FAA Initiative to Address Noise Concerns of Santa Cruz/Santa Clara/San Mateo/San Francisco Counties

Work Group Meeting

September 28 2016

Proposed Herringbone Approach

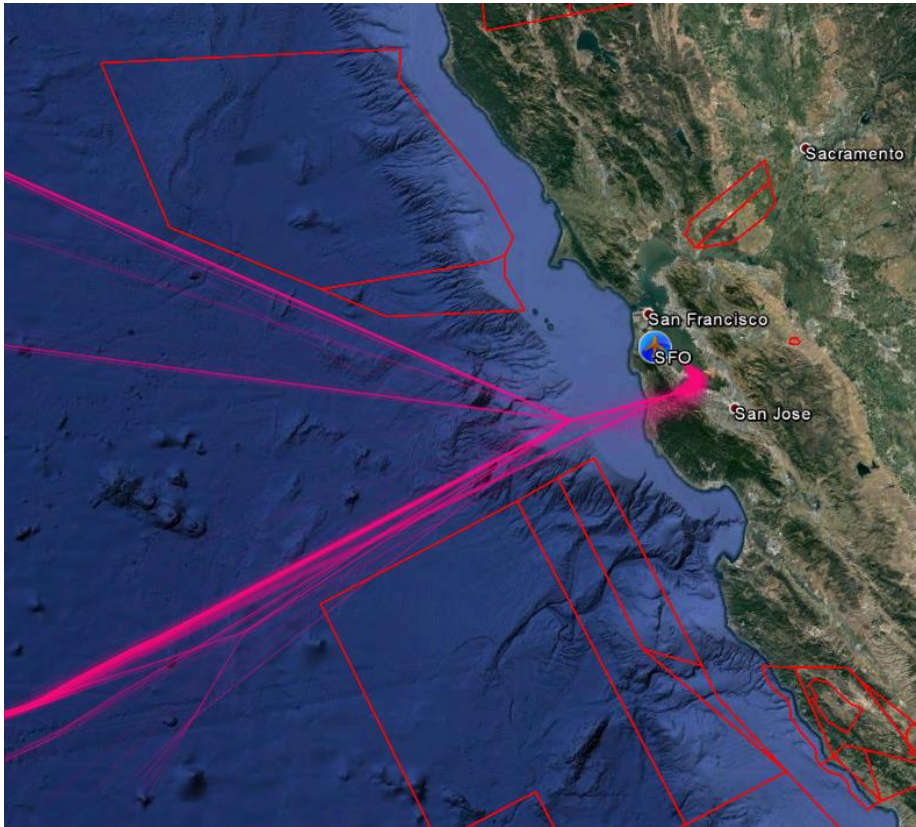
- The waypoints on the herringbone are separated by 3 NM (minimum IFR separation). This does not account for:
 - Heavy and Super class aircraft, which require between 4 to 8 NM separation.
 - Different aircraft flying characteristics, including performance, weight, weather, etc.
- A 'slot' on the SERFR would be required for an aircraft to be merged via the herringbone approach.
- The herringbone approach would cause a major safety concern when vectoring is necessary for sequencing.

Constraints of “fanning”

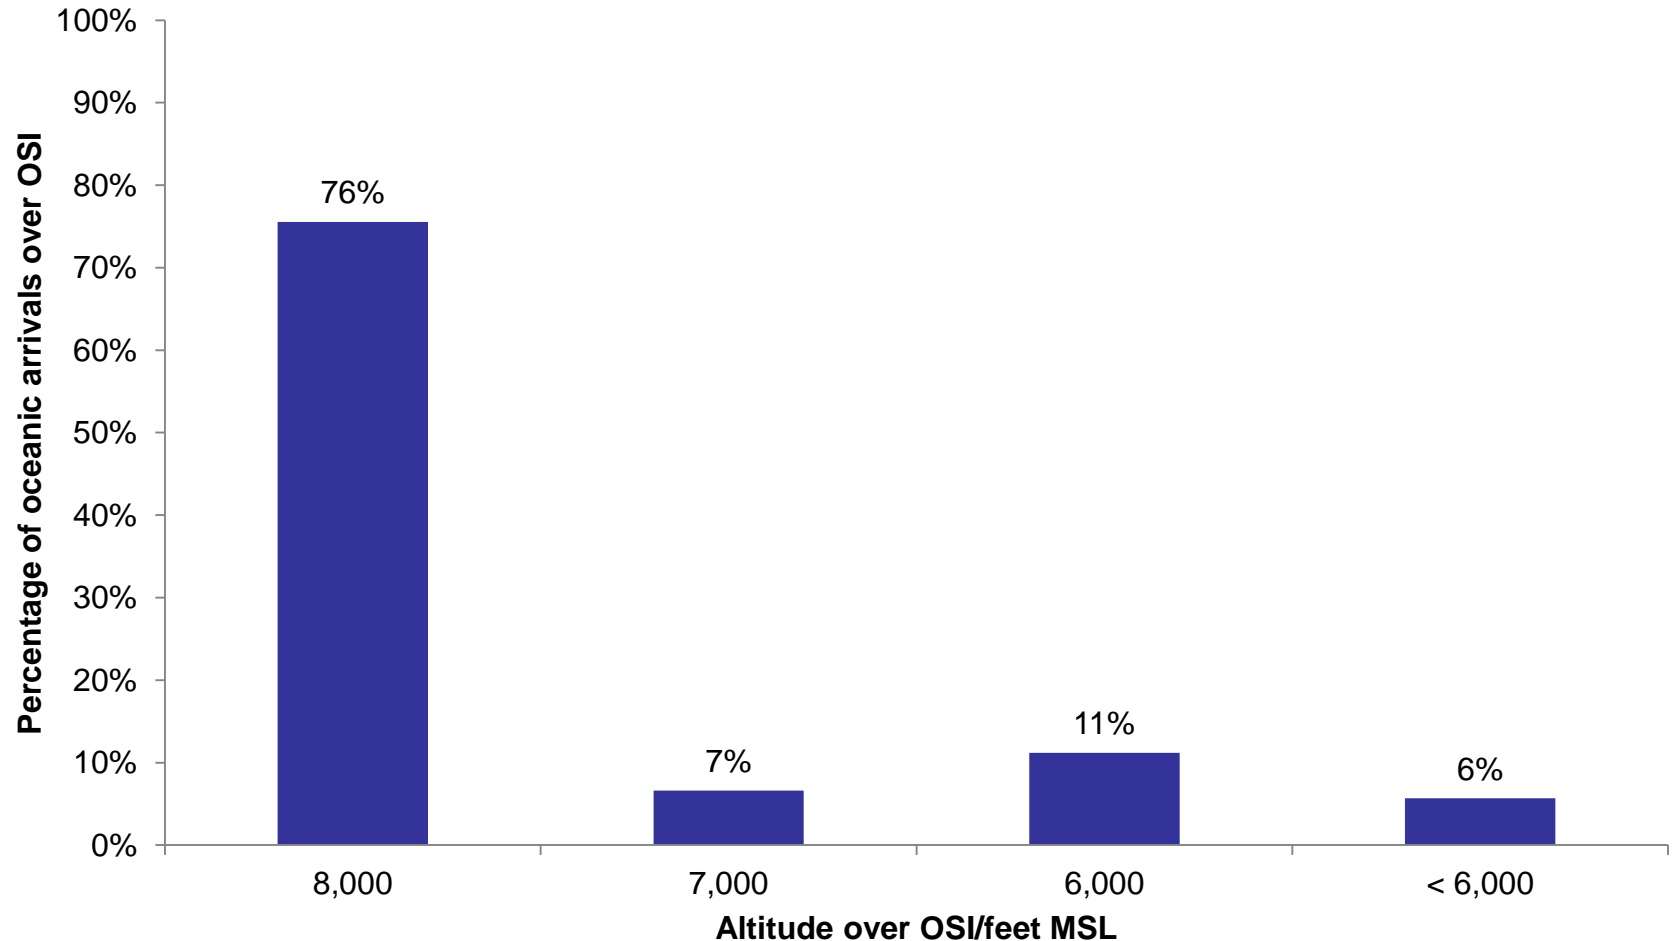
- Offshore Special Use Airspace limits the location where the oceanic arrivals cross land.
- Once the oceanic arrivals cross land, spacing and sequencing needs to be accomplished as they are merged with SERFR and BDEGA arrivals.

Analysis of Flights over Woodside

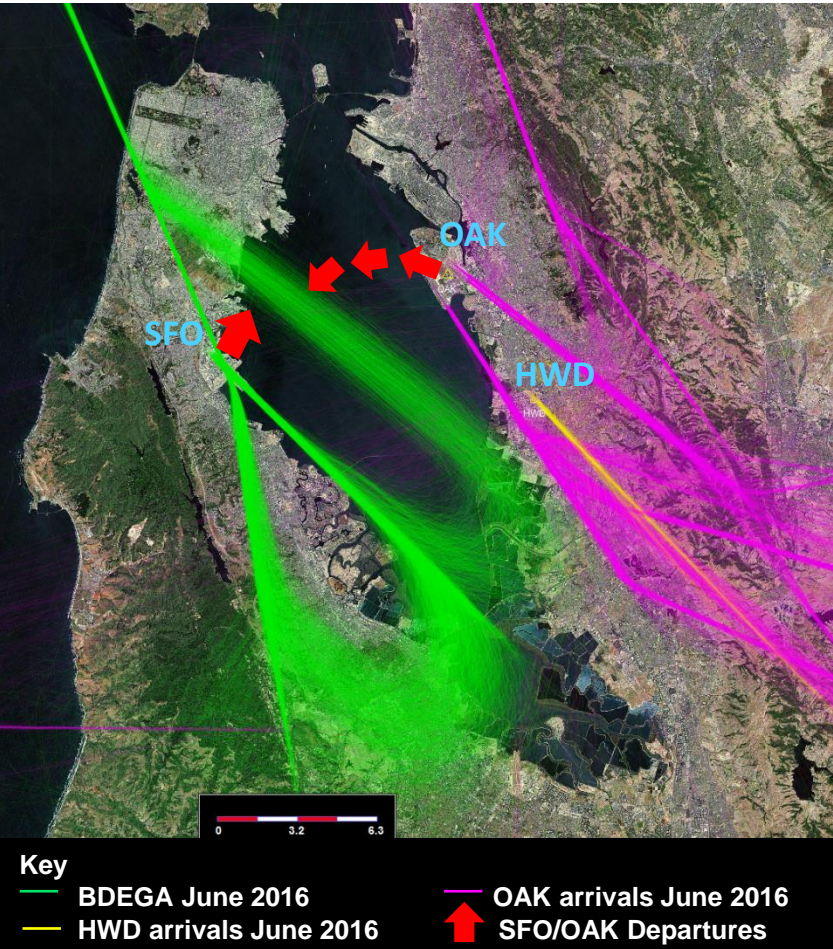
- **Approximately 75% of flights are at 8,000 feet over Woodside**
- **Some proportion of flights at 7,000 and 6,000 feet MSL fly the Optimized Tailored Approach (OTA).**
- **The OTA is a privately held procedure which enables aircraft to be on autopilot from takeoff until landing at SFO. It is primarily used for long haul flights i.e. from the far east.**
- **NCT is working with all carriers which are flying under 8,000 feet at OSI while not on the OTA, to fly at or above 8,000 over OSI.**

Usage: BDEGA East Leg

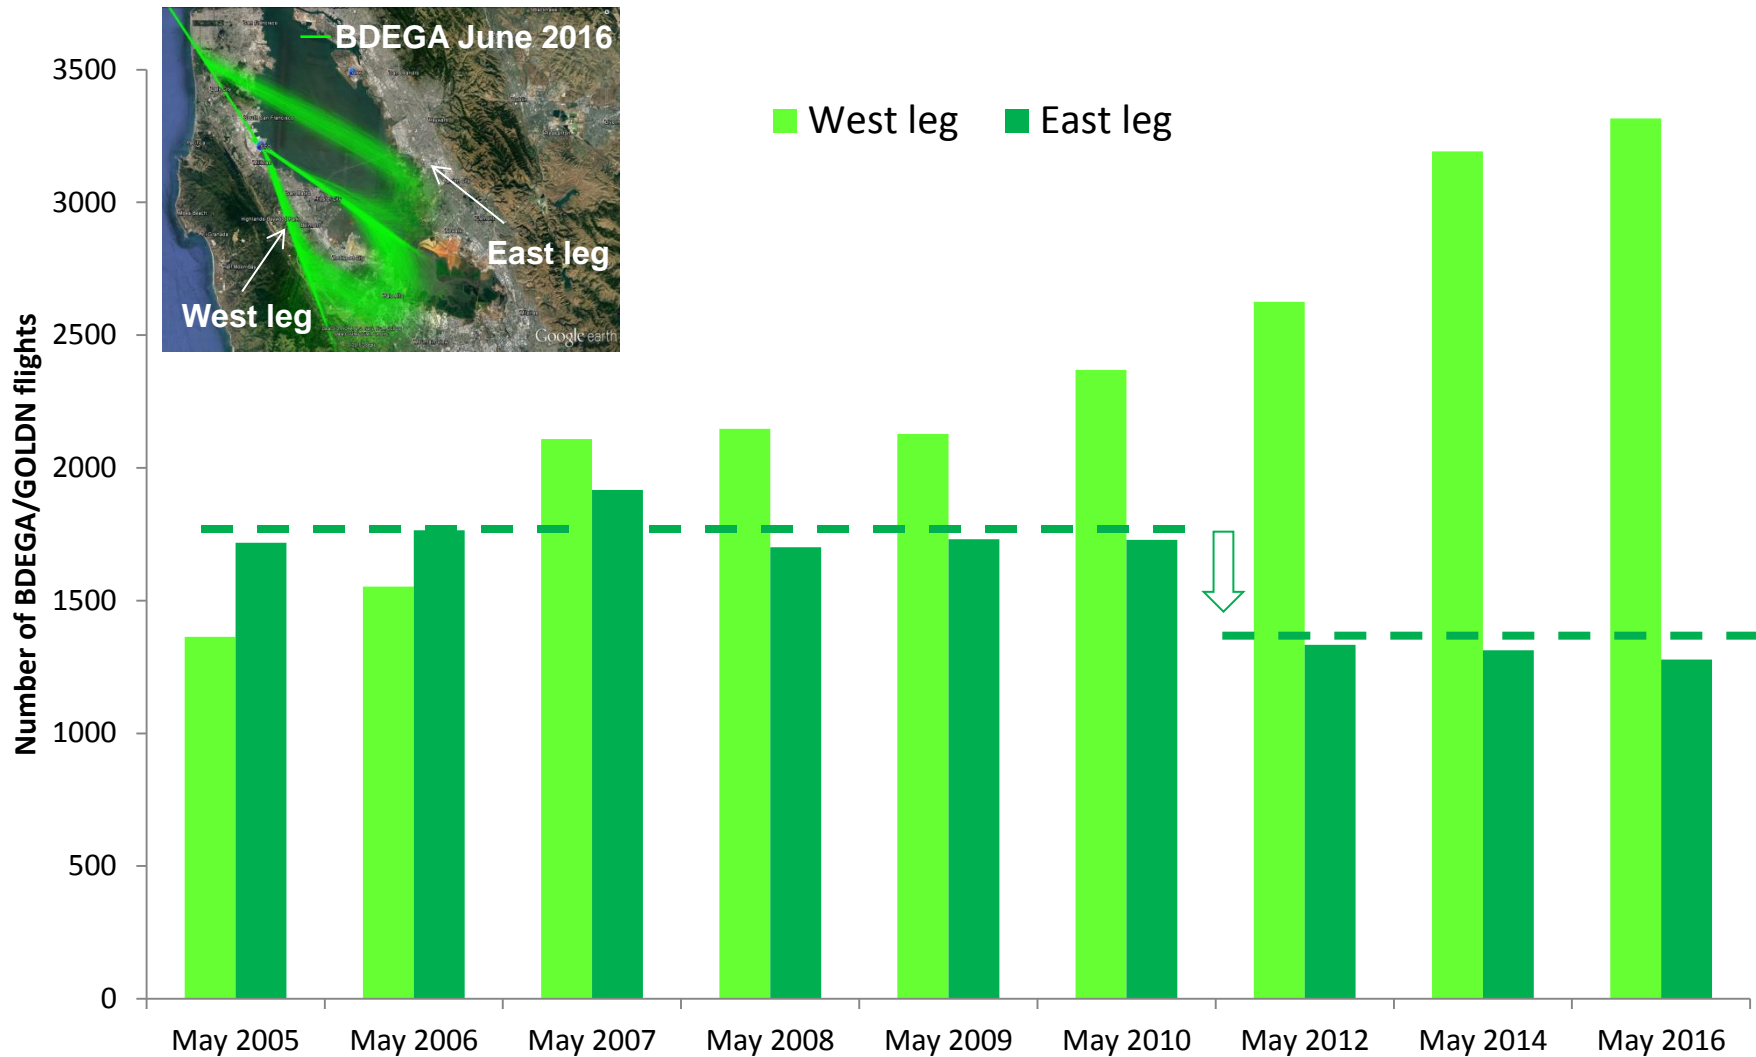
- The east leg has the potential to conflict with SFO/OAK departures and OAK/HWD arrivals.
- Volume on DYAMD arrival.
- The east leg requires a tighter turn to final than the west leg.
 - Harder to maintain a stabilized approach, especially for newer aircraft.
 - Aircraft operators have requested more stabilized approaches.

Usage: BDEGA East/West Legs

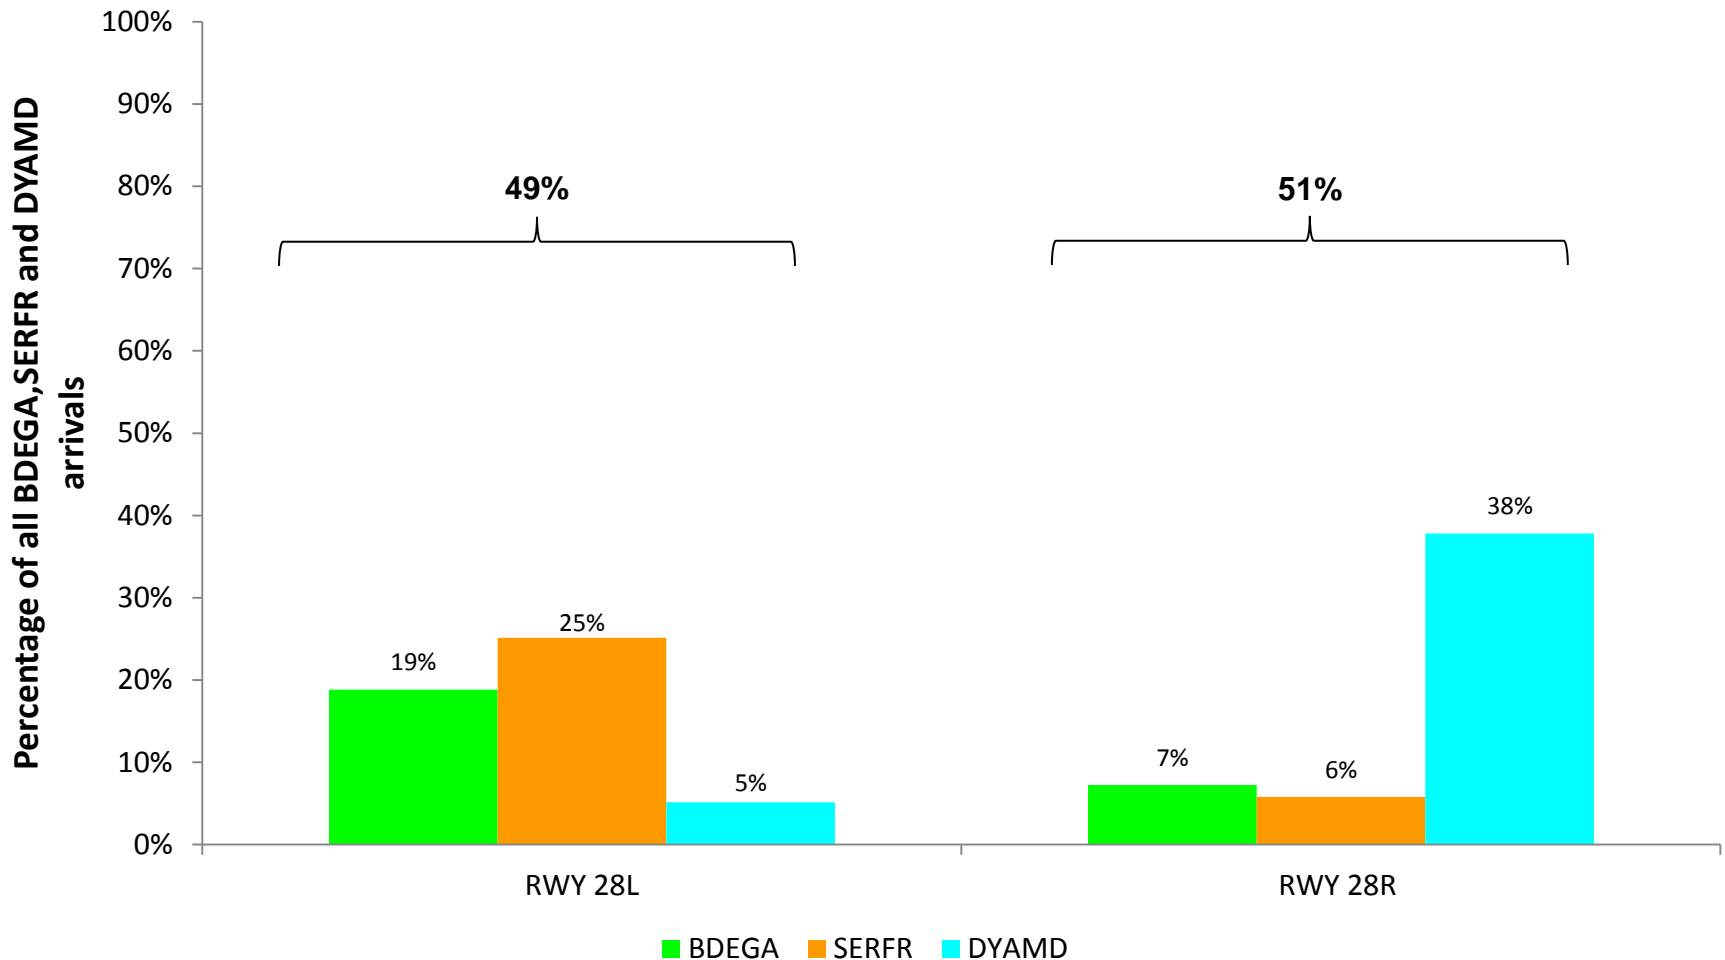
- **There was a consistent level of usage of the BEDGA East leg until between 2010 – 2012. The usage of the BGEDA east leg dropped after this point.**
- **There has been increasing use of the BEDGA West leg**
- **There is a limitation to East Leg usage:**
 - RWY 28R is predominately used by DYAMD arrivals, as designed.
 - The east leg of the BDEGA conflicts with OAK and SFO departures
 - The east leg requires a tighter turn to final than the west leg, resulting in a shorter final. This is harder to maintain a stabilized approach, especially for newer aircraft.
- **The east leg of the BDEGA is used as much as operationally feasible.**

1. MENLO East (to Golf Course)

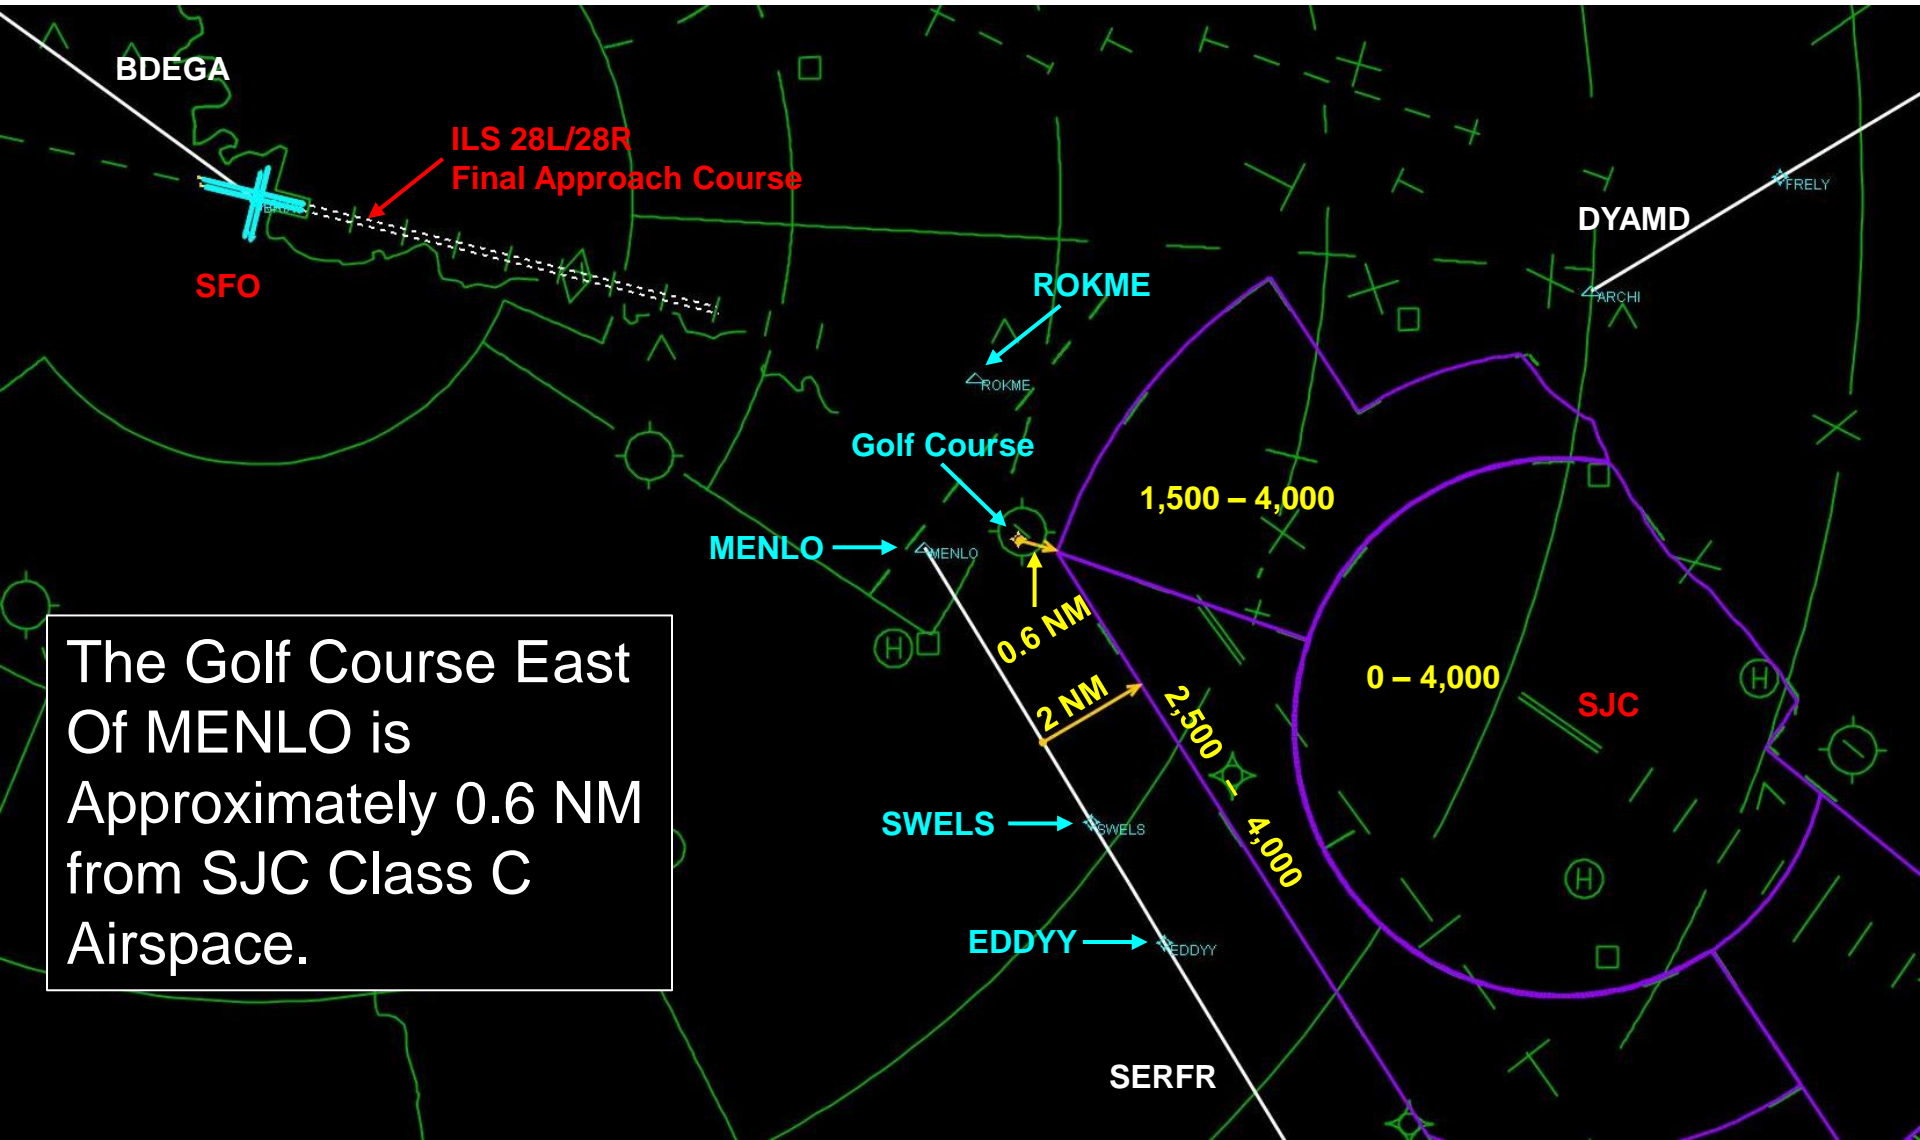
- **MENLO cannot be moved East.**
 - Too close to SJC Class C.
- **ROKME cannot be used in place of MENLO.**
 - Violates the transition area to join the final approach course.
 - MENLO is an IAF, ROKME is not.
- **The altitude at MENLO cannot be raised to 5,000 feet.**
 - Creates an unsafe descent rate that will negatively impact aircraft joining the final approach course.

2. Use ROKME in place of MENLO

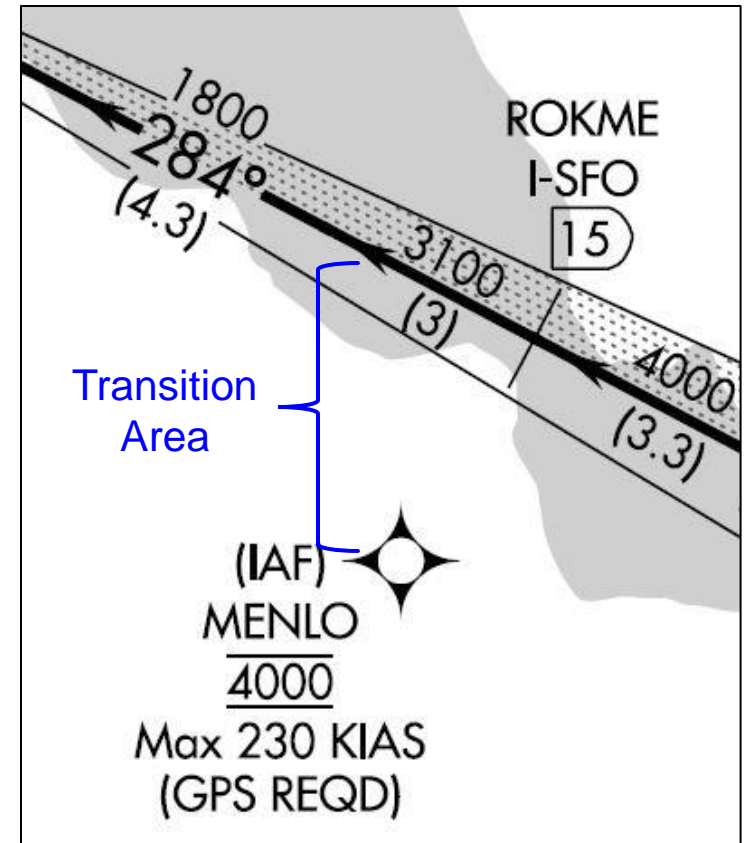
MENLO is an Initial Approach Fix (IAF) on the ILS RWY 28L

The SERFR STAR includes a 'Transition' – the space between the end of the STAR (MENLO) and where the aircraft intercepts the Final Approach Course (the straight-line path the aircraft flies down to the runway).

Using ROKME instead of MENLO would remove the Transition Area, leaving insufficient space for aircraft to intercept the RWY 28L or 28R final.

2. Use ROKME in place of MENLO

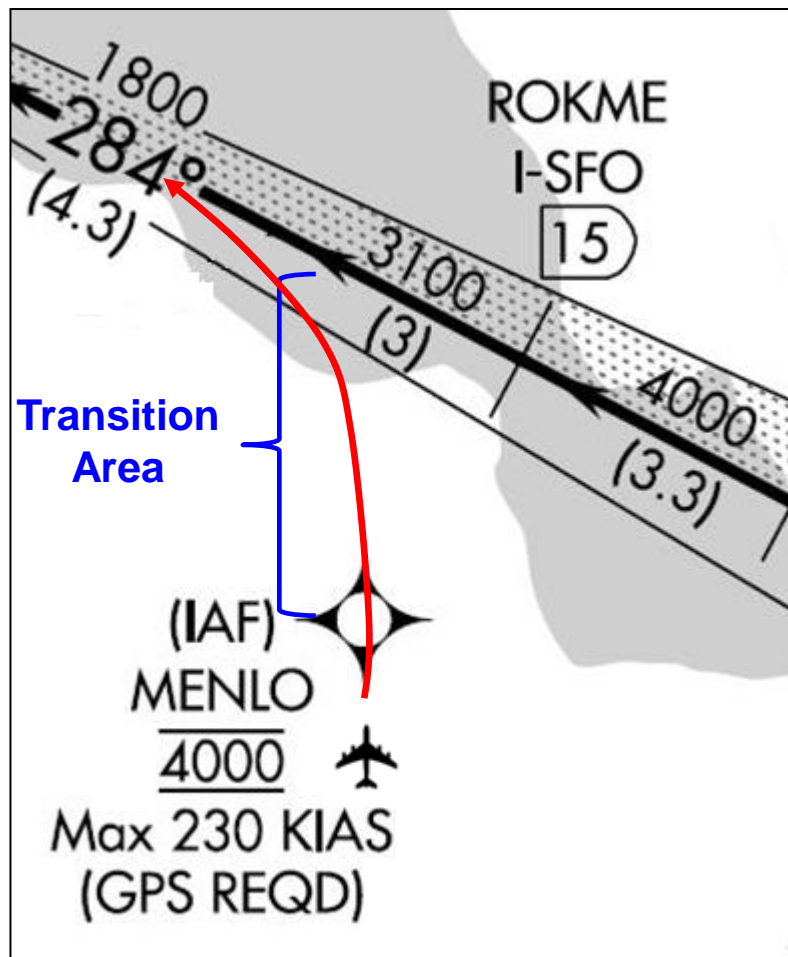
- The Transition Area is required for aircraft to make the turn from the SERFR STAR to the Final Approach Course.
- Aircraft intercepting a final approach course must do so from an angle of 30° or less.
 - Using ROKME instead of MENLO will violate the requirement.
